Subject: Public Comment – Low Emission Diesel Study (“LED Study”)¹

Executive Summary

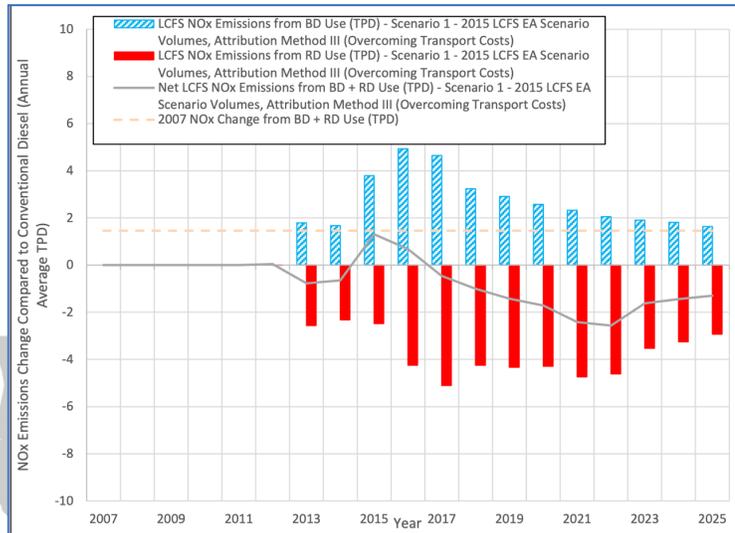
Page G-31 provides an overview of the most recent emissions reduction model relying on RD NOx reductions, which can no longer be claimed because of the LED Study findings, and NTDE penetration (see the following graph). Given RD’s absence of any offset, there is a significant amount of annual NOx increases as a result of biodiesel use dating back to 2013. From 2013-2021, based on CARB’s illustrative model,

approximately 10,000 tons of NOx emissions were emitted from biodiesel and went unaccounted for in CARB’s 2016 SIP.
